24590-LAW-PCN-ENV-19-008

**Hanford Facility RCRA Permit Modification Notification Form**  
**Part III, Operating Unit 10**  
**Waste Treatment and Immobilization Plant**

Modification to the Hanford Site RCRA / WTP Dangerous Waste Permit consisting of updates to Piping and Instrumentation Diagrams for the LAW Melter Feed Process System (LFP), LAW Secondary Offgas / Vessel Vent Process System (LVP), and Radioactive Liquid Waste Disposal System (RLD). Updates performed are in accordance to WAC 173-303-830, Appendix I Modification citation number: A.3., equipment replacement or upgrading with functionality equivalent components (e.g., pipes, valves, pumps, conveyors, controls).

The purpose of this Class <sup>1</sup> modification is to provide Piping and Instrumentation Diagrams (P&IDs) for the LAW Melter Feed Process System (LFP), LAW Secondary Offgas/Vessel Vent Process System (LVP), and Radioactive Liquid Waste Disposal System (RLD) for incorporation into Appendix 9.2 of the WTP RCRA permit:

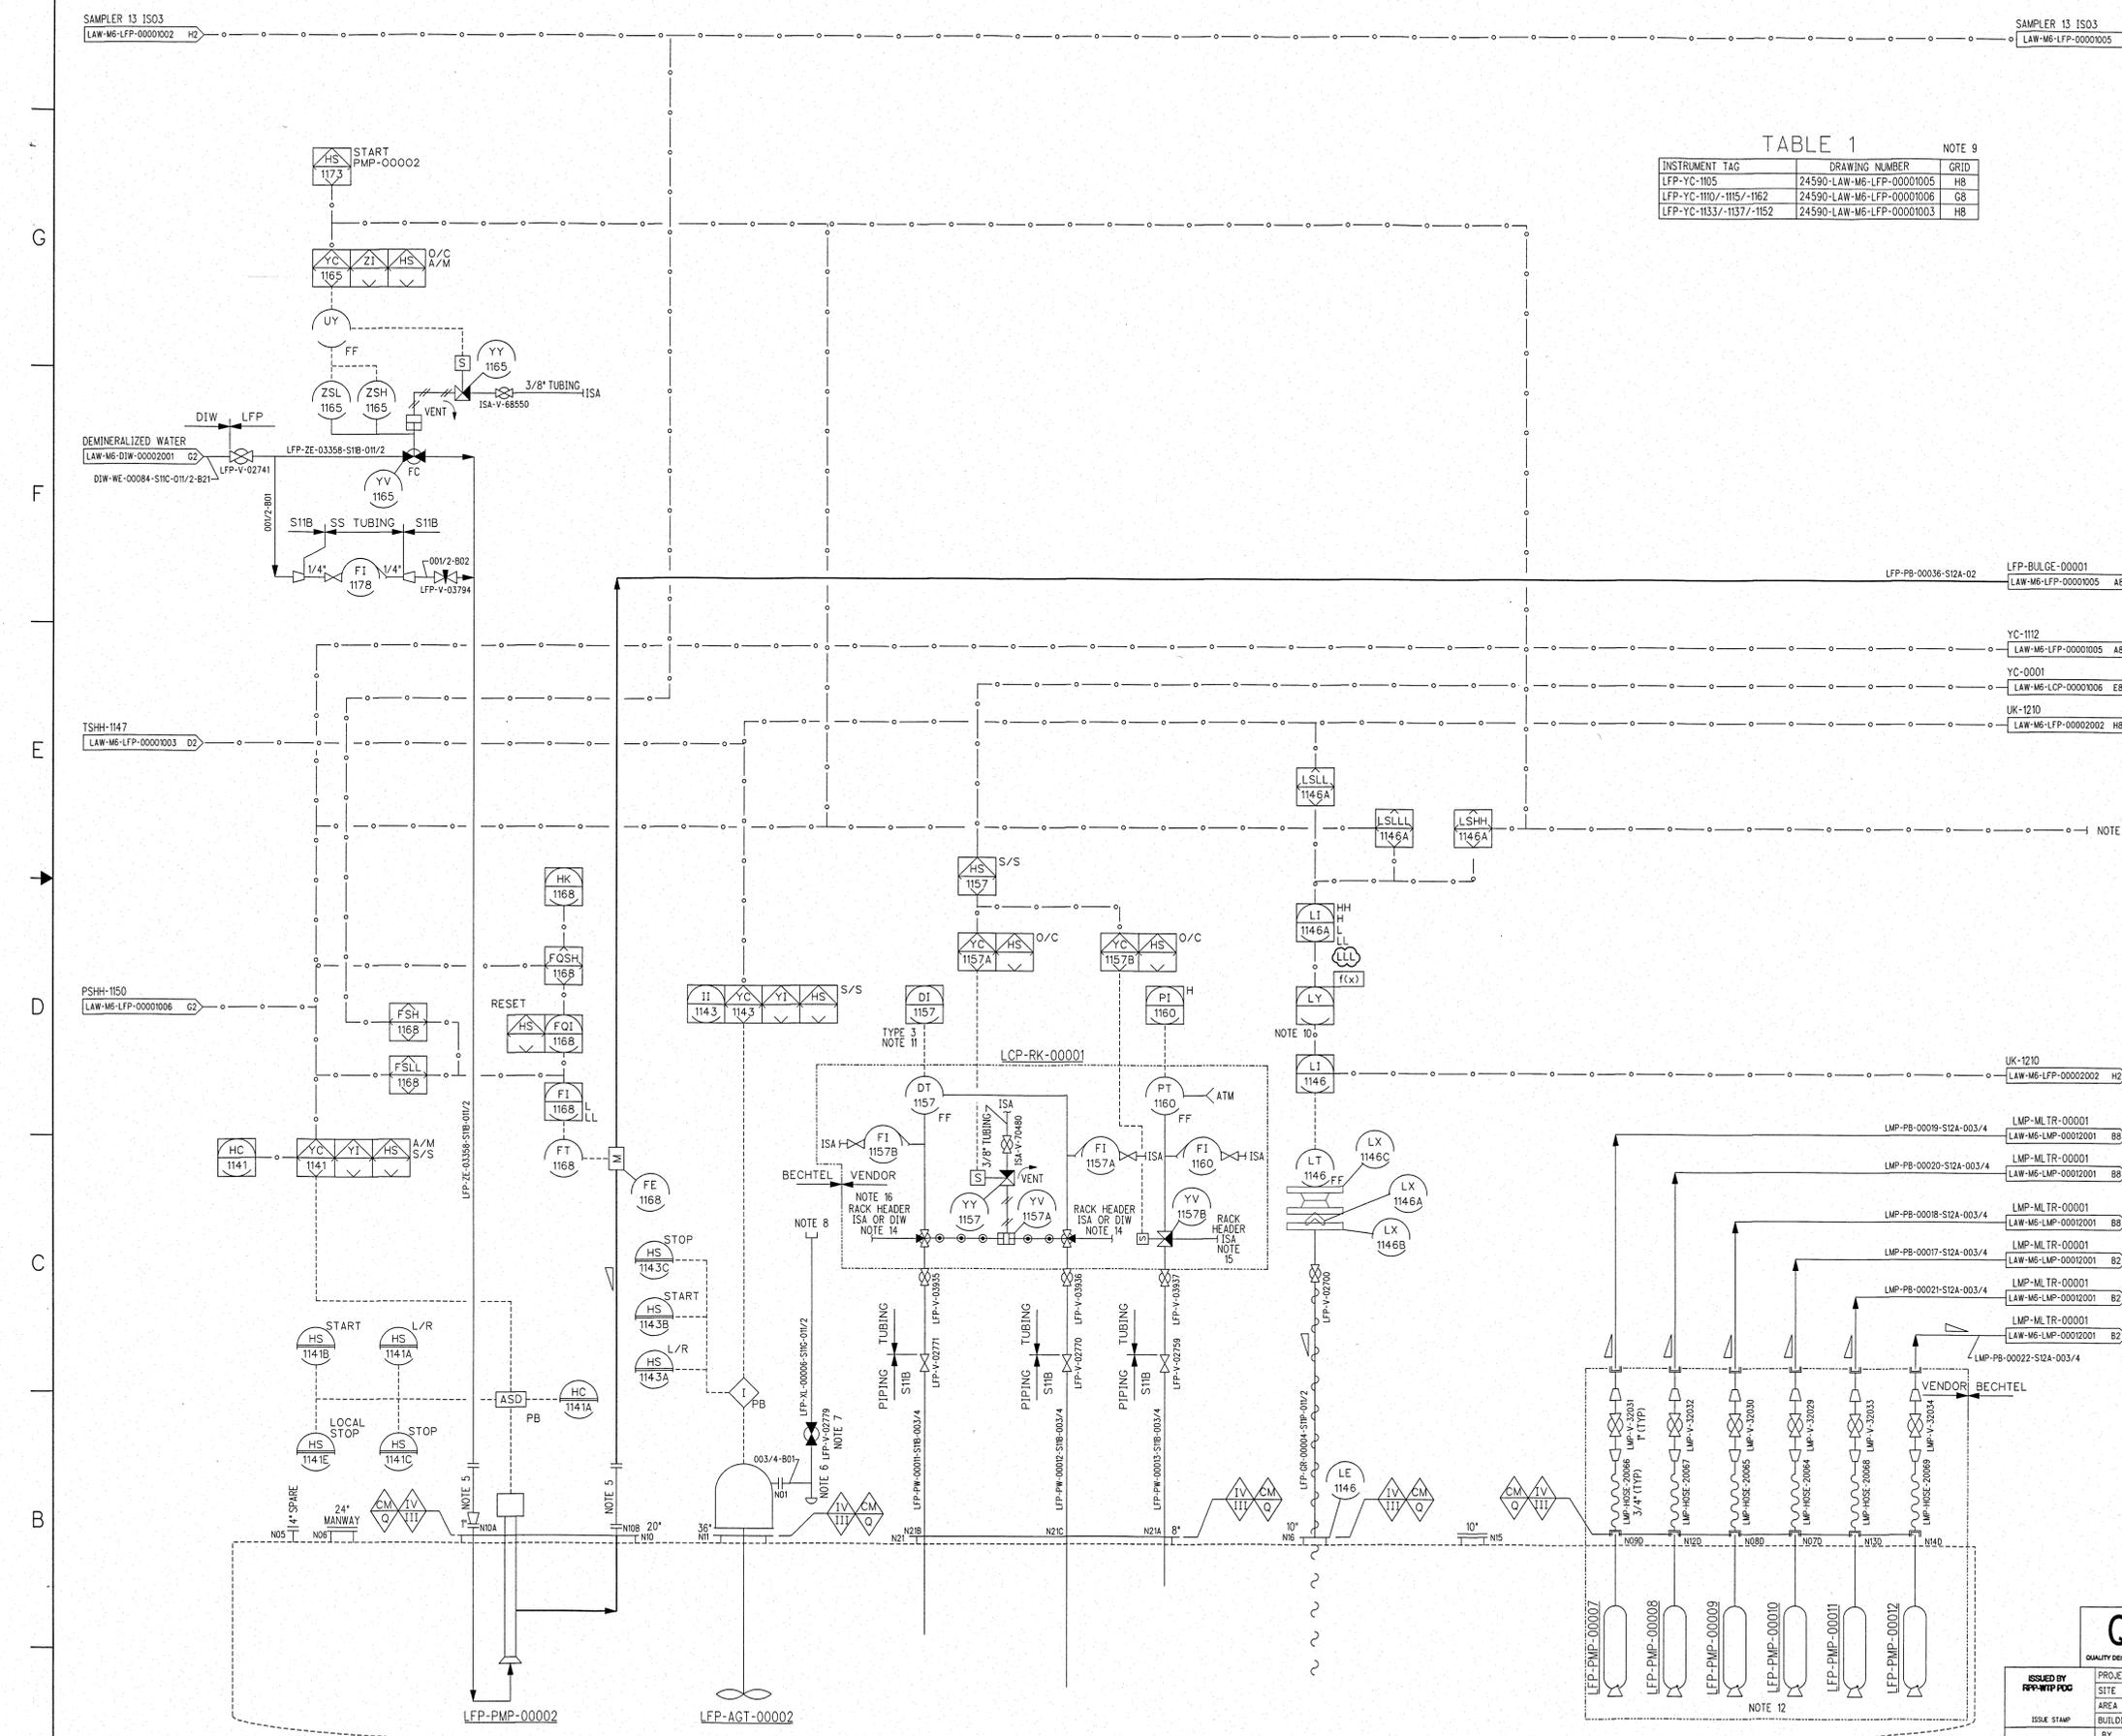
1. Significant changes incorporated into the Piping and Instrumentation Diagram (24590-LAW-M6-LFP-00001004, Rev. 3) for Melter 1 Feed Vessel LFP-VSL-00002 of the LAW Melter Feed Process System are summarized below.
  - a. See 24590-LAW-M6-LFP-00001004, Rev. 2 for intervening revisions.
  - b. Addition of Note 19, Revision 2, incorporation of piping and instrumentation diagrams as well as revision to engineering impact evaluation to align with project requirements.
  - c. Addition of Note 20, Revision 3, Low-Low-Low alarm added onto instrument LI-1146A.

- REVISION 3: ADDED LOW-LOW-LOW ALARM ON INSTRUMENT LI-1146A IN RESPONSE TO 24590-WTP-GCA-MGT-19-00347.
